SUBJECT: Response to February 24, 2011 Letter: KANSAS STATE UNIVERSITY –
REQUEST FOR ADDITIONAL INFORMATION REGARDING THE REQUEST
FOR POSSESSION LIMIT INCREASE FOR THE KANSAS STATE UNIVERSITY
TRIGA MK-II NUCLEAR REACTOR FACILITY (TAC NO. ME4730).

Kansas State University TRIGA Mk II Possession Limit Increase Request
RESPONSE TO REQUEST FOR ADDITIONAL INFORMATION

FIGURE 2 - SIDE VIEW OF MCNP MODEL, COLOR-CODED BY MATERIAL.

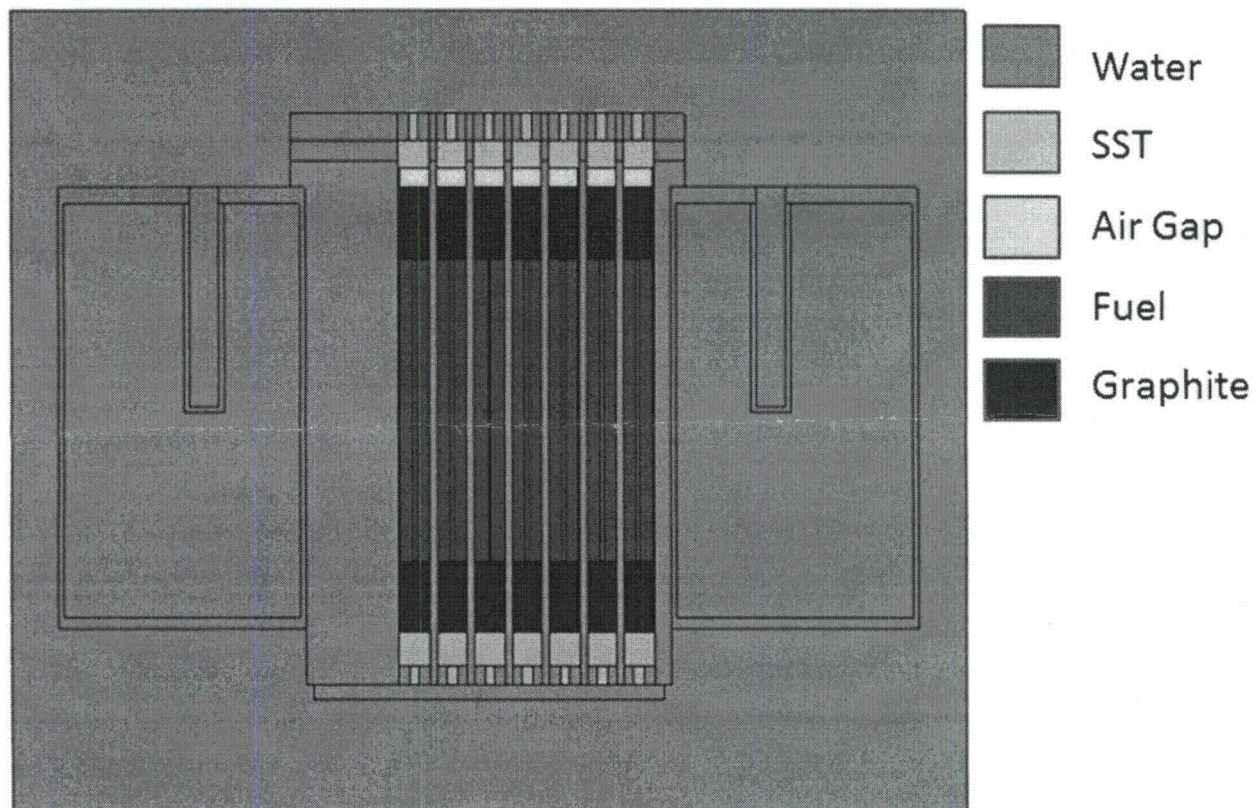
2. NUREG 1537, Part 1, Chapter 9.2, "Handling and Storage of Reactor Fuel," provides guidance to demonstrate that subcriticality is ensured. Your November 1, 2010 letter indicated that the new fuel would be stored in sets of two racks, with the fuel in two rows of six (6) fuel elements, but at different axial elevations to reduce neutron coupling. However, the KSU SAR, Section 9.2, Fuel Handling and Storage of Reactor Fuel Rev. 5/08, indicates that the fuel racks allow only for single row spacing up to six elements. Please clarify the storage orientation of the fuel storage racks and if a change to SAR is needed.

Chapter 10.2 of the SAR describes the fuel storage geometry as single rows of six elements per row, whereas the license amendment request referred to axially-offset double rows of elements. The fuel racks consist of either single rows of (up to) six elements, or two rows in the same polar location, but separated by 29" of vertical distance. Since the fueled region of TRIGA elements is 15" in length, the fueled region of two elements will be separated by at least 14" of distance if the elements are in the double racks. This separation distance is many mean free paths for a thermal neutron in water, and sufficiently decouples the two rows that they are effectively two single rows. Therefore, the SAR description is accurate. However, the Facility also believes that the SAR description of the racks as single rows was confusing, and a clarification to the geometry of the racks in SAR 10.2 will be pursued.

In the MCNP model used in the Facility's criticality safety analysis of 12%-loaded fuel stored in the in-pool fuel racks, the racks were modeled as seven elements long, with no vertical separation between the two rows. The model was a modification of an existing model of the reactor, so the graphite reflector was in the model geometry. The removal of the graphite reflector lowers k-effective to 0.66627 +/- 0.00022, which is lower by a large margin than the limit of 0.8 given in the Technical Specifications, section 5.2. With this modification, the fuel elements are modeled in a large pool of water, which is conservative compared to the actual storage geometry, in which concrete occupies approximately half the solid angle about the fuel element storage racks. The fuel rack metal was not included in the model. The location of fourteen fresh 12%-loaded fuel elements in one set of two racks is extremely conservative. If the fresh fuel was mixed with irradiated elements, or fresh elements with lower loading, the k-effective would decrease due to a decrease in the ^{235}U content (and therefore the reactivity) of the irradiated or lower-loaded elements relative to the fresh 12% elements.
